CITY OF SAN ANTONIO

Re: The Boulders at Canyon Springs Subdivision

MDP # 806

MASTER DEVELOPMENT PLAN FOR THE BOULDERS AT CANYON SPRINGS A RESIDENTIAL COMMUNITY

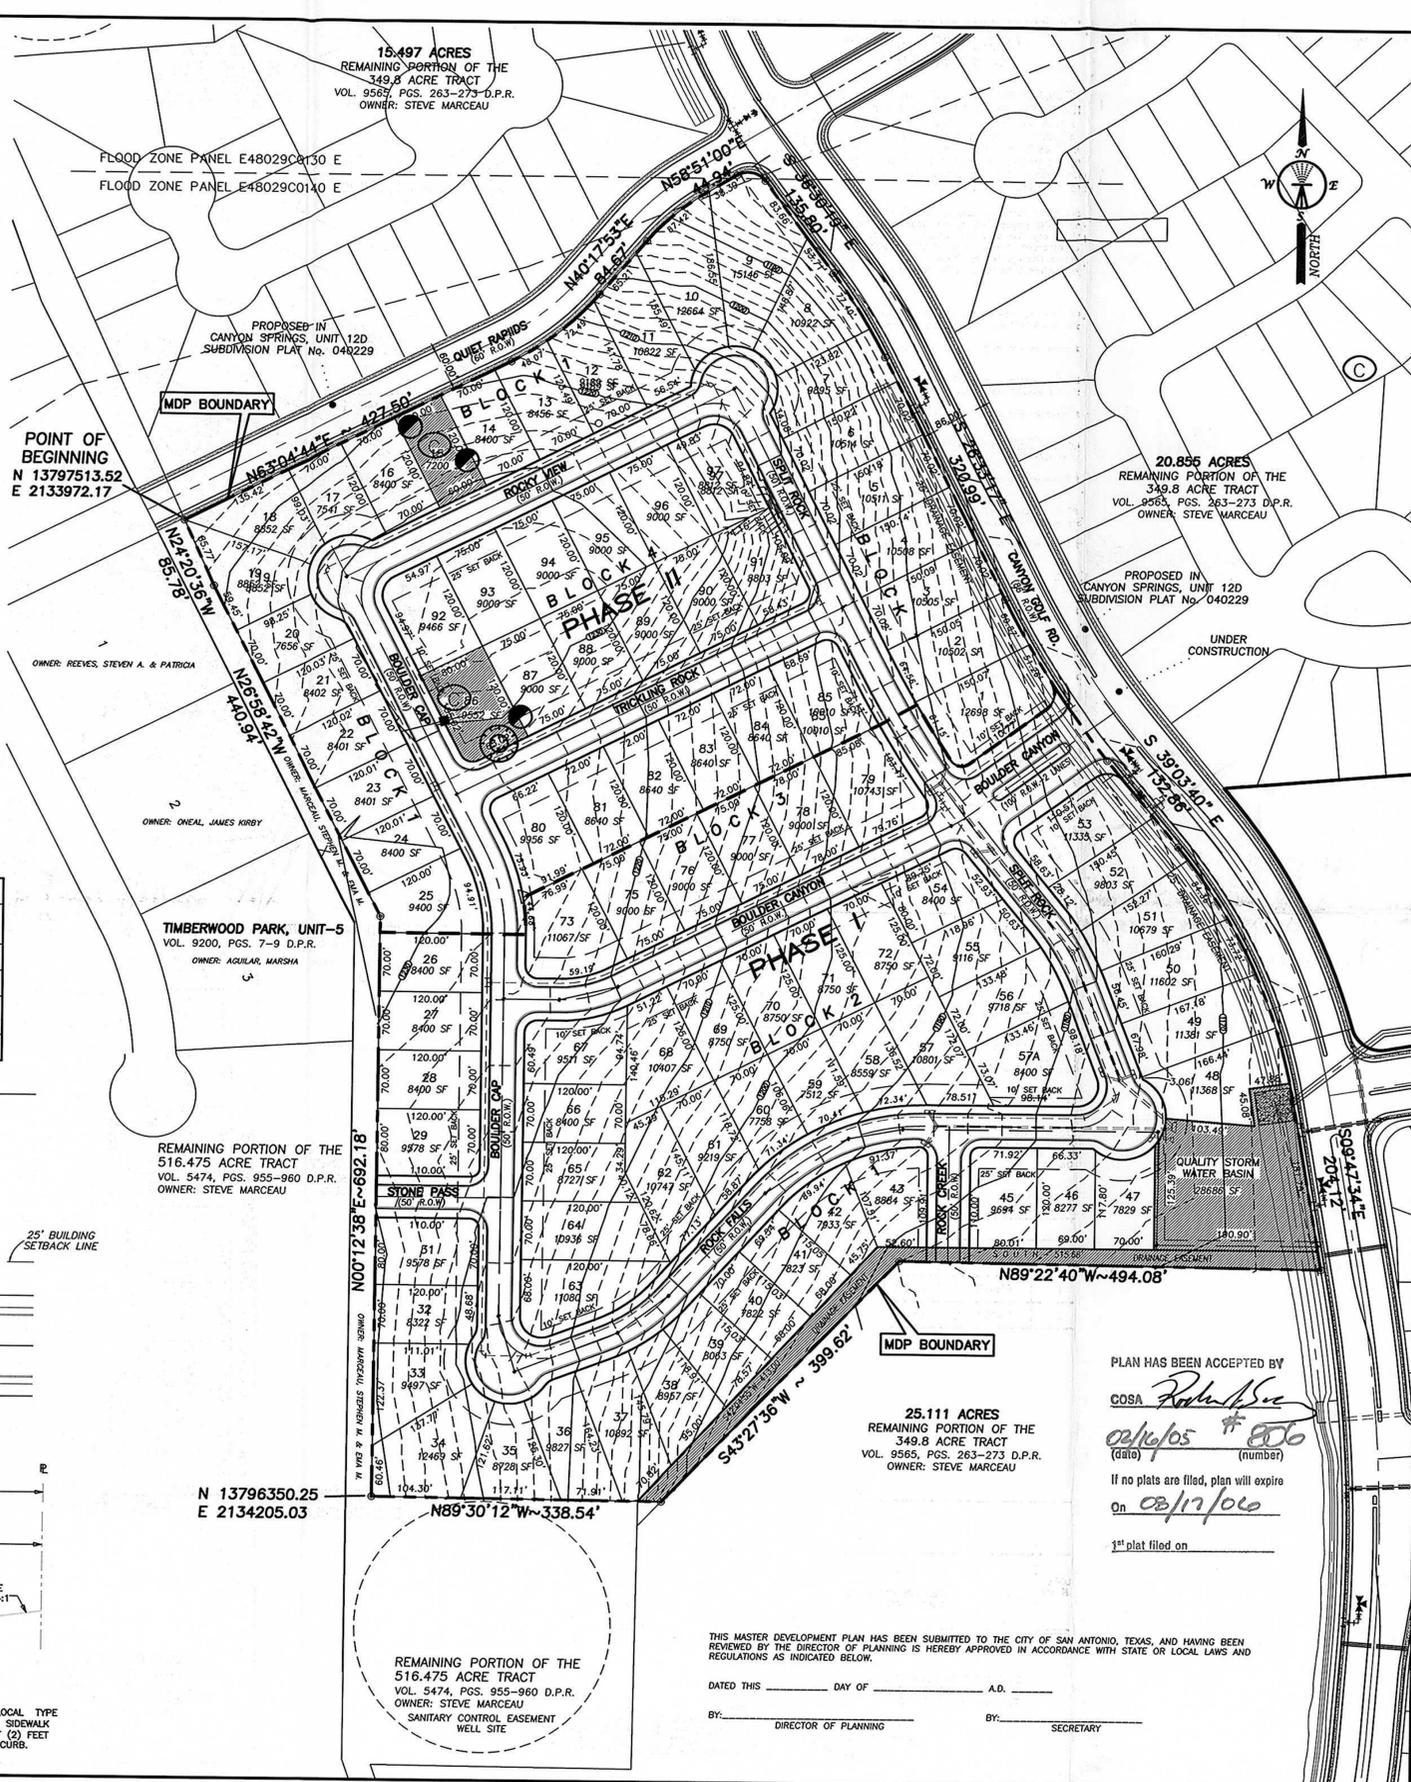
- Streets and Drainage approves this project with the following conditions:
 - a. Provide for pavement transition at the entrance intersection of Boulder Canyon Drive and Boulder Canyon Drive and Balcones Cavern Loop.
 - b. Add a general note that states, "all intersections will comply with the clear vision area requirements of Section 35-506(d)(5) of the Unified Development Code".
 - c. Clarify the street notes, 31' B/B and 28' B/B.

The following issue should be addressed during the respective platting process: Evaluate providing additional street names so that intersection reference points are unique. You currently have two (2) intersections of Golden Canyon Drive and Balcones Cavern Loop, etc.
